MM-2001 PINSETTER

Fenix Service Bulletin Number MM-001

Figure 1

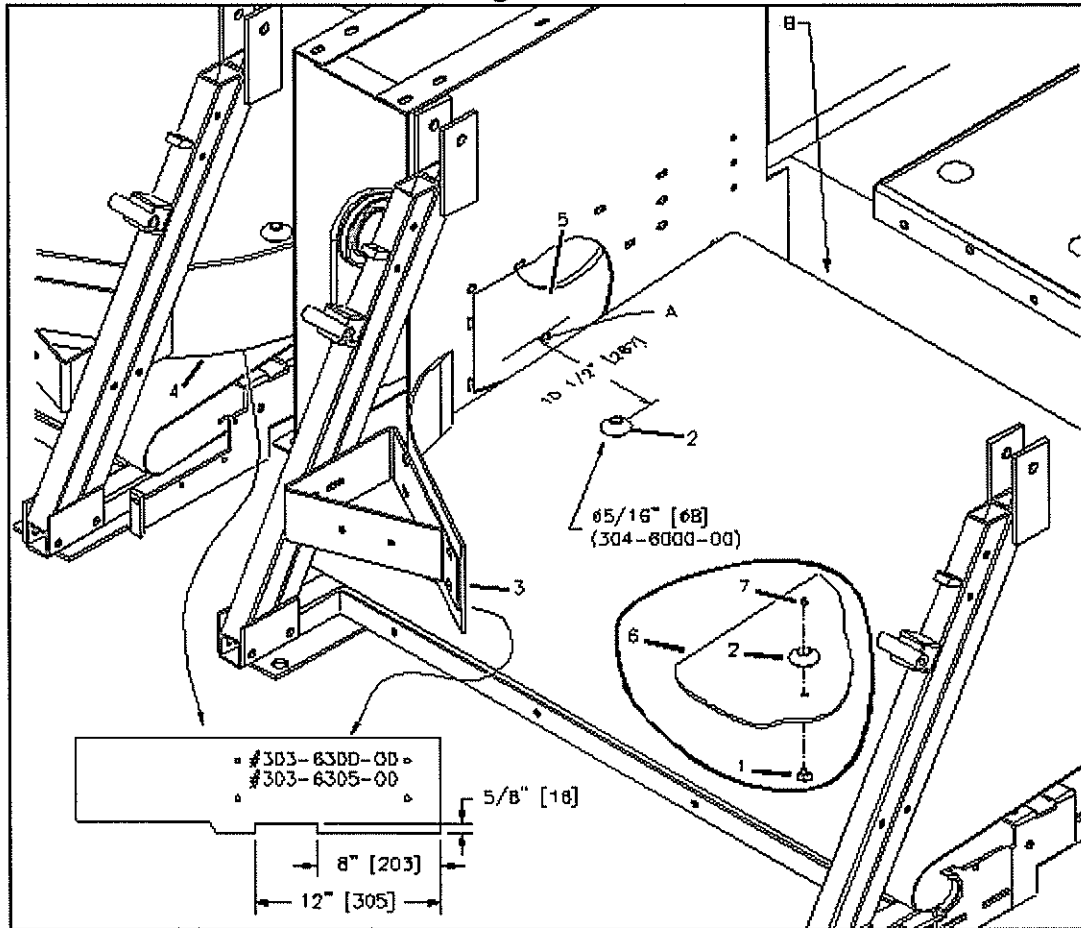
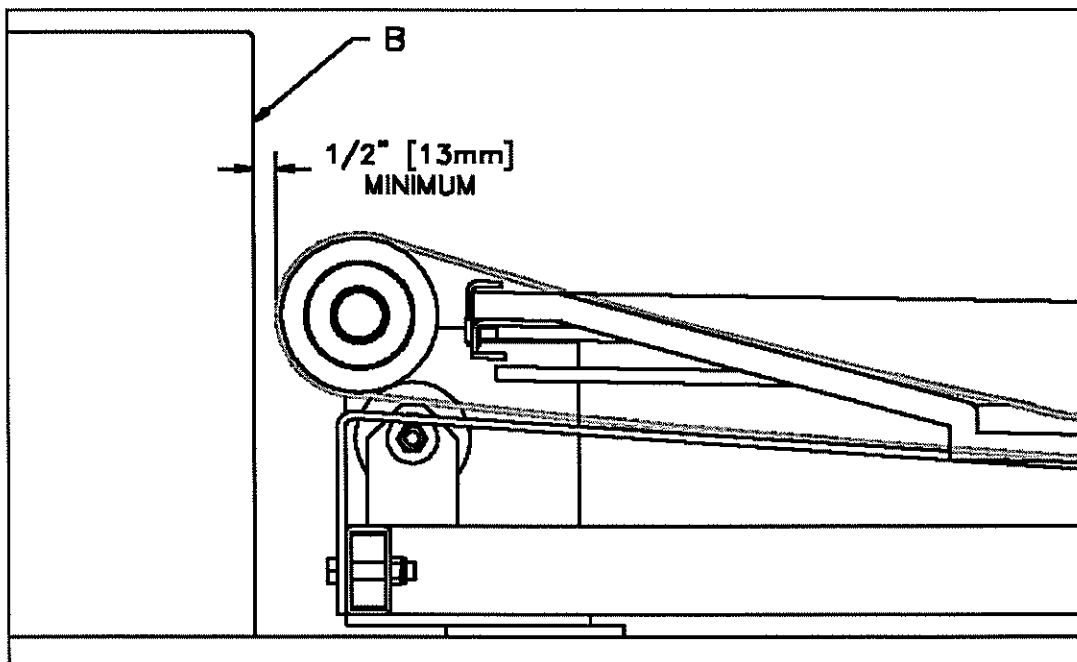
This modification is fully compatible with any pinsetter and is available from Mendes under the part number 399-6000-00 (Pin Deflector Modification Kit).

Measure 10" 1/2 (267mm) (**Figure 1, A**) from the ball door (303-6560-00 / 303-6565-00). Punch a 5/16" (8mm) diameter hole in the pit carpet. Put together the elevator bolt (302-6005-00), the pin deflector (303-6000-00) and the thin nylon nut (7044-002520-000) as shown in **Figure 1** and tighten them together.

Remove the pit deflector (303-6300-00/303-6305-00) and make a notch as shown in **Figure 1**.

Before running the machine; check for clearance between the front of the pit conveyor belt (304-6000-00) and the tailplank (**Figure 1 & 2, Item B**). The clearance has to be at least 1/2" (13mm) to clear the path for the pin deflector (303-6000-00). If not, make a groove in the tailplank to allow safe passage.

**Replacement of the Elevator Up Deflector***Décember 1998*

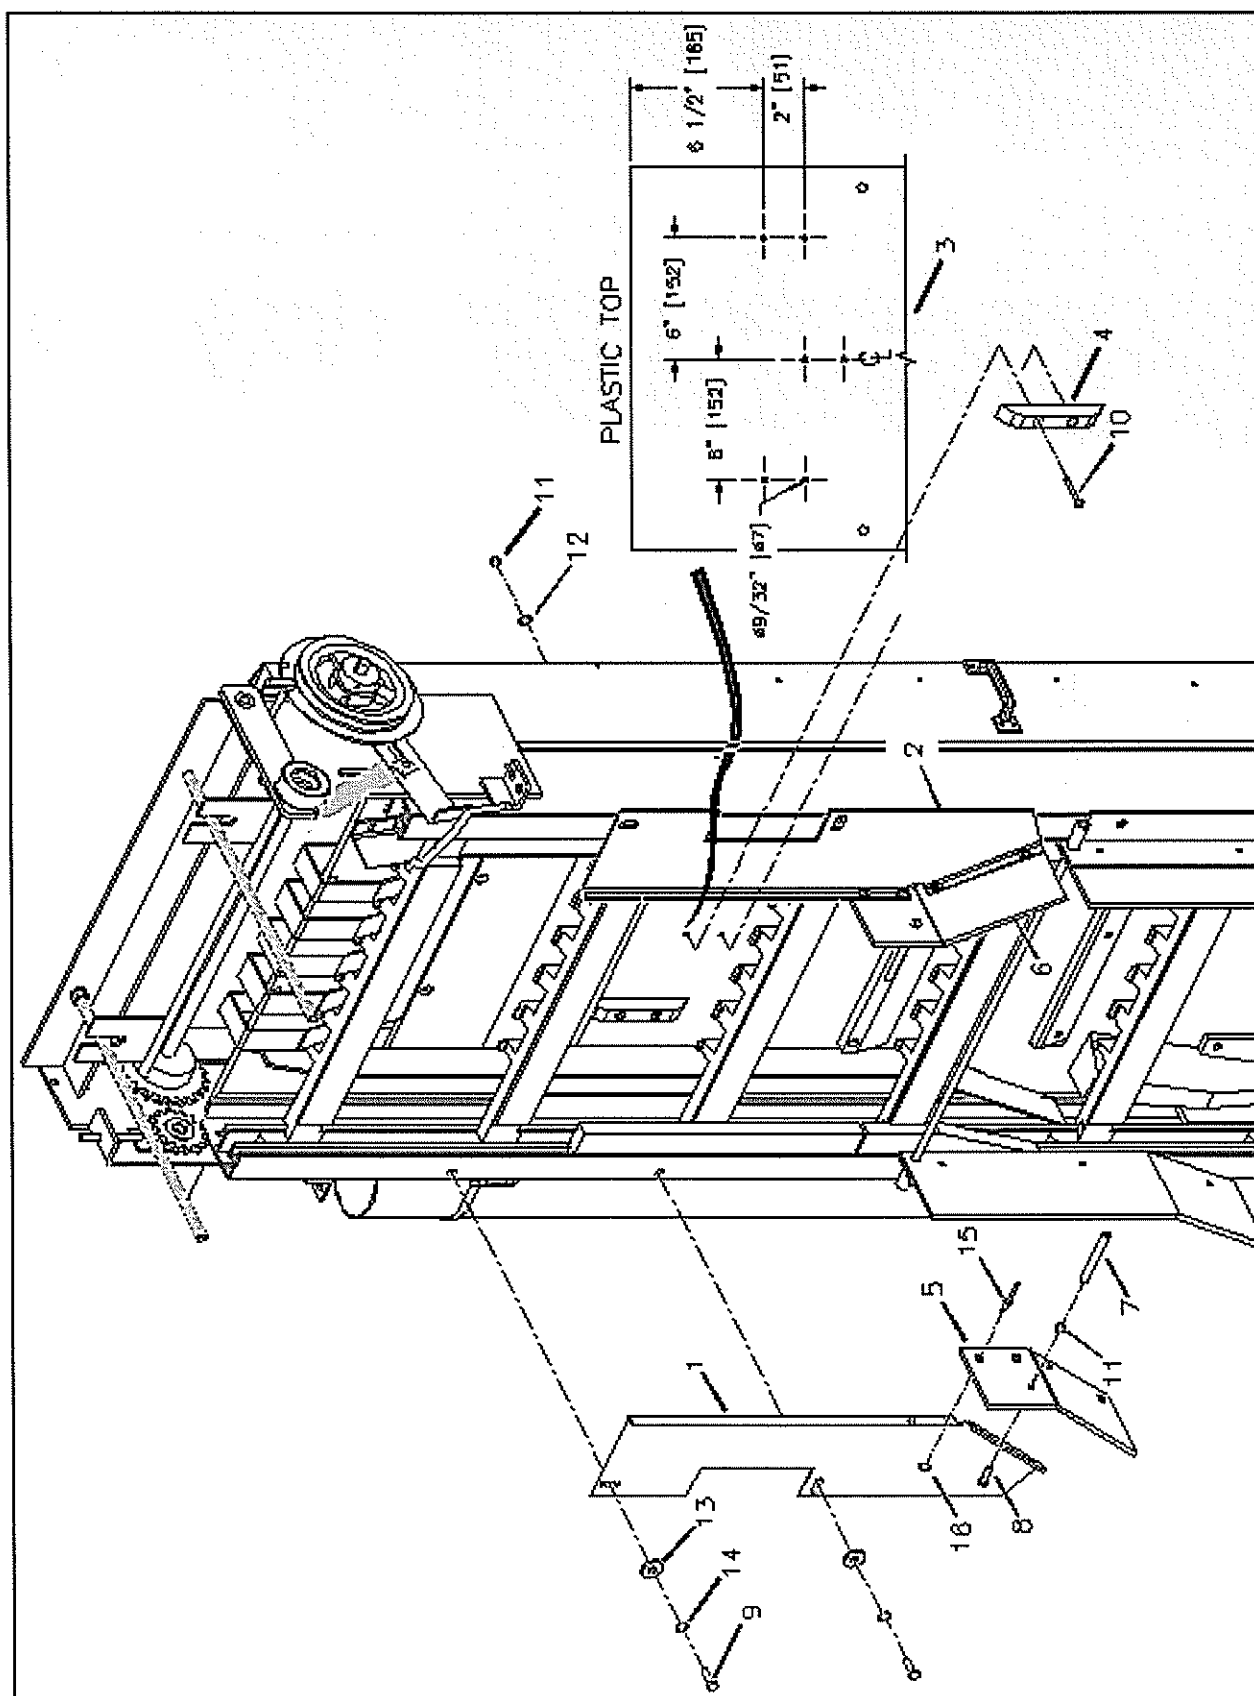
This modification is fully compatible with any pinsetter and is available from Fenix under the part number 322-8310-00 & 322-8315-00. (Parts for the modification of one pinsetter)

- Remove the old "Up Deflector" and install the new one in the same position.
- If you install the new "Up Deflector", you also need to install two positioning plates (303-8110-01) as described in **Figure 1**. Each of the elevator already as one "Positioning Plate" (303-8110-01) installed (Check if it is the same model). You need to remove this one and instal it with the new one, in the correct position. (**Figure 1**)

**Replacement parts for the installation of the deflector block.***Month and Year*

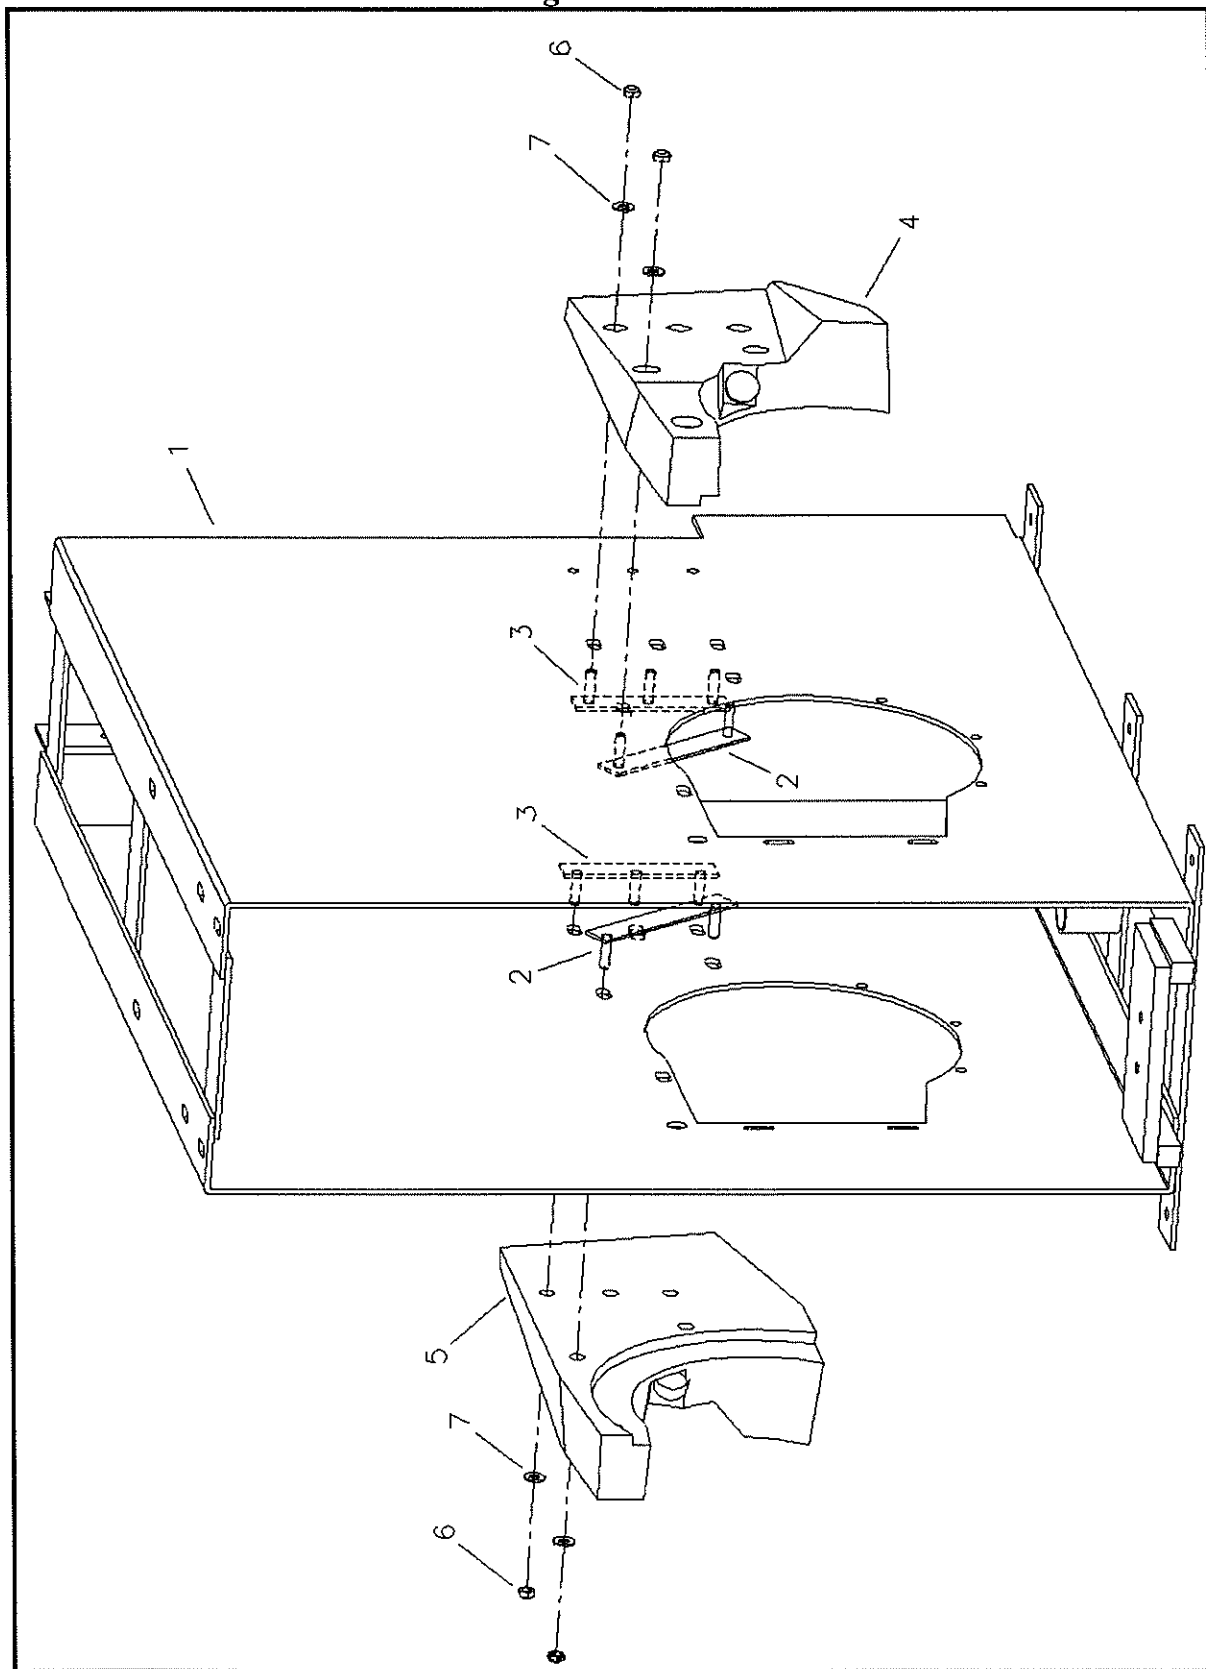
Starting with MM-2001 pinsetter serial number MM-_____, we replaced the « Weld Nut » (7046-003118-037) inside the « Kickback Assembly ». This modification is fully compatible with any pinsetter.

If you encountered this problem, remove the « weld nut » inside the « kickback Assembly » and install the two « Deflector Block Mounting Plate » (302-6680-00 & 302-6690-00). With these new parts in place, it will be necessary to use « thin nylon nut » (7044-003118-000) and the « washer » (7050-034068-008).
